# METROPOLITAN GOVERNMENT OF NASHVILLE AND DAVIDSON COUNTY

## STAFF RECOMMENDATION 1508 Elmwood Avenue June 20, 2012

**Application:** Violation – Request to Retain Garage Not Constructed as Approved  
**District:** Belmont-Hillsboro Neighborhood Conservation Zoning Overlay  
**Council District:** 18  
**Map and Parcel Number:** 10416038300  
**Applicant:** Frank George, contractor  
**Project Lead:** Sean Alexander, sean.alexander@nashville.gov

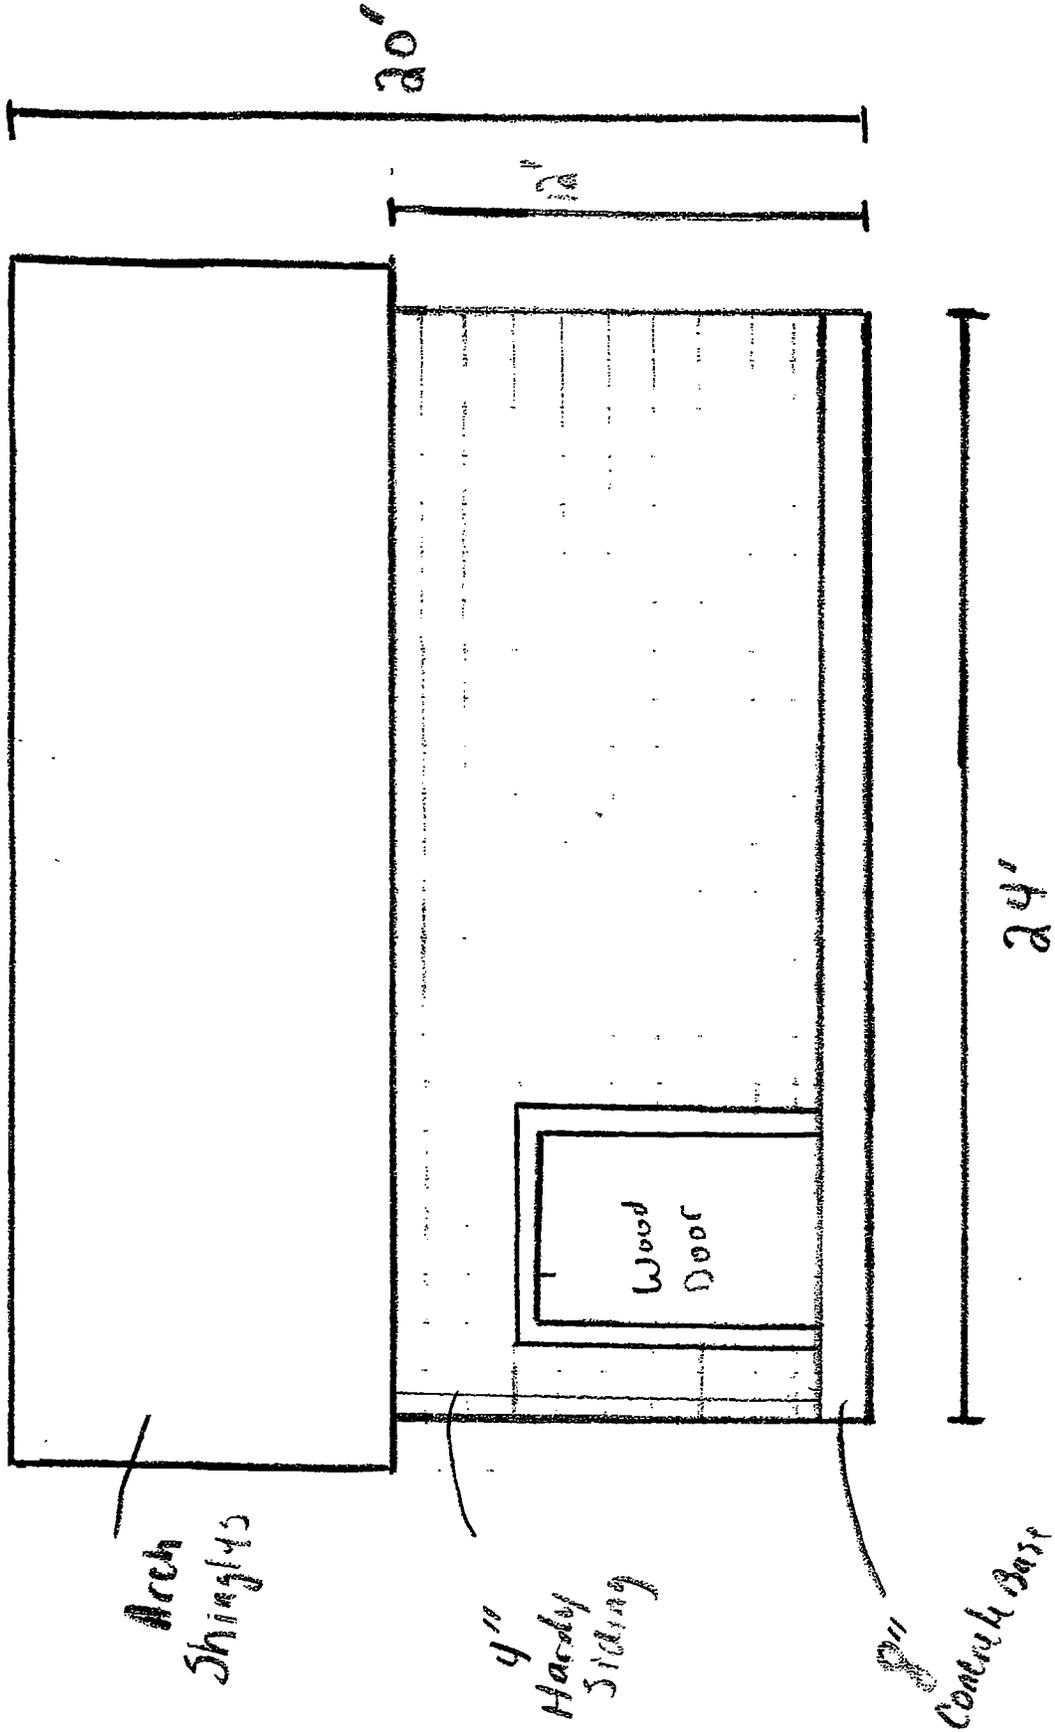
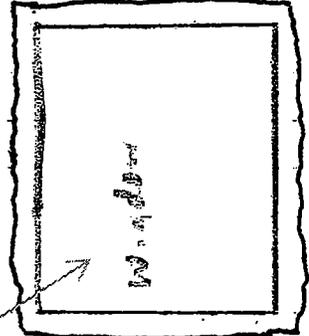
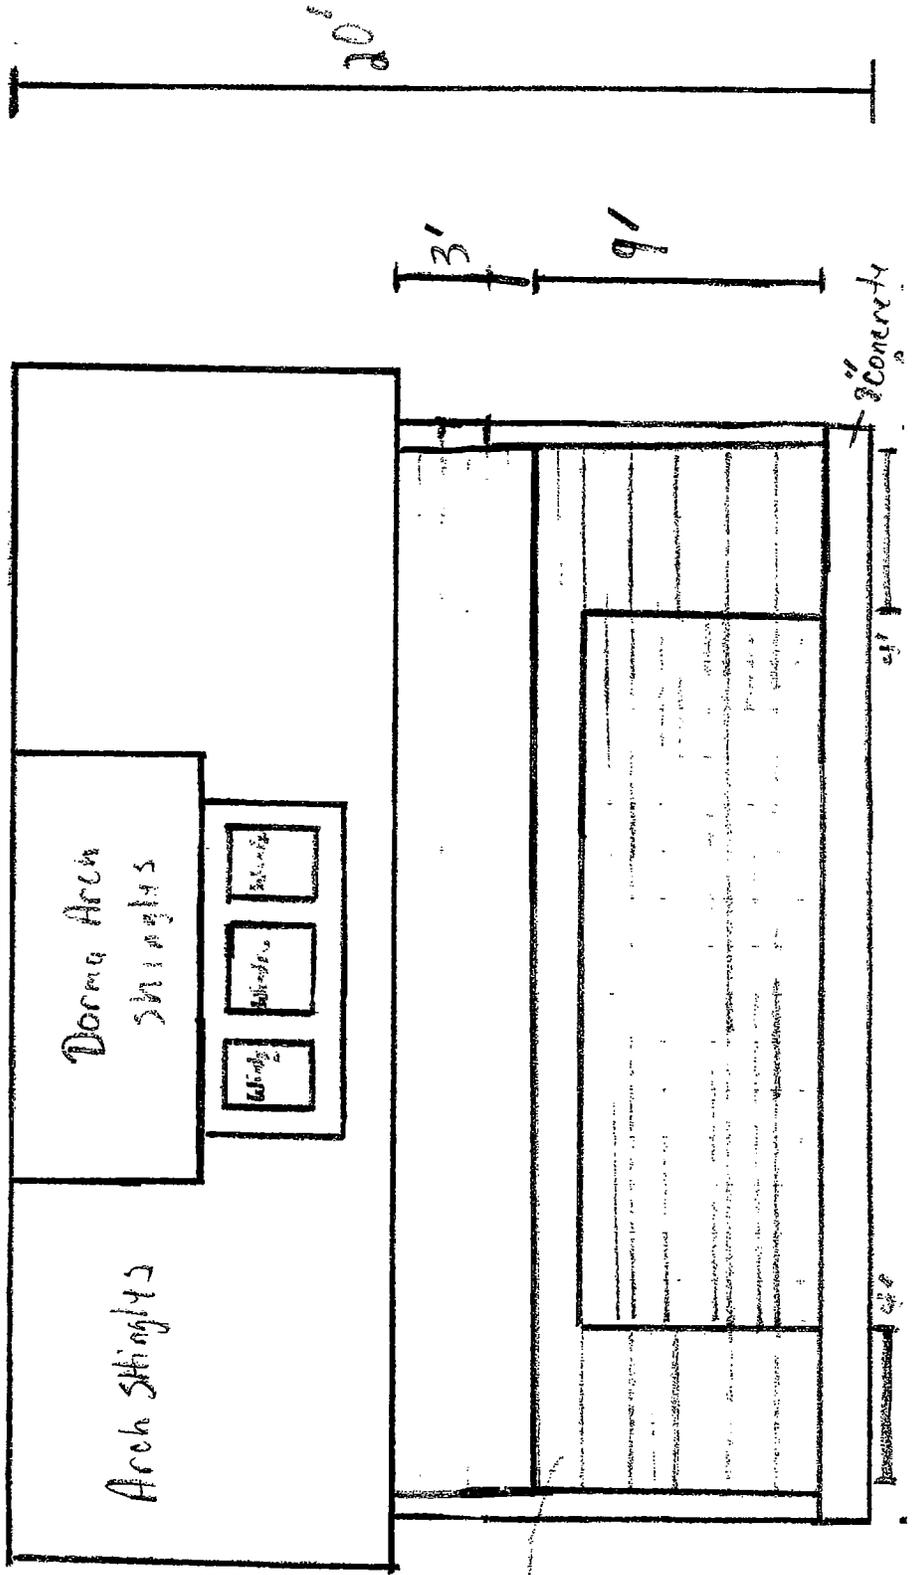
The structure was approved to have a six hundred square foot (600 sq. ft.) footprint, and would be twenty feet (20') tall with a twelve foot (12') eave height with a ridge line that was parallel with the alley. As built, the structure has the correct footprint and overall height, but the eaves are fifteen feet (15') above the finished floor level and the ridge is oriented perpendicular to the street rather than parallel, which increases the perceived massing of the structure from the public right-of-way. Due to a rise in grade from the house to the alley, the structure appears to have an additional three feet (3') of height as viewed from the right-of-way.

The approved drawings indicated that the structure would have a gable with an 8:12 pitch, with the ridge running parallel to the street. The structure was built with a 5:12 roof pitch and the ridge running perpendicular to the street. What was to be an alley-facing shed dormer was built facing the side, and was not set in as approved but stacked directly on the wall below.

**Recommendation:** Staff recommends disapproval of the application to finish construction of the accessory building in deviation from the permit issued by Staff on April 27, 2012.
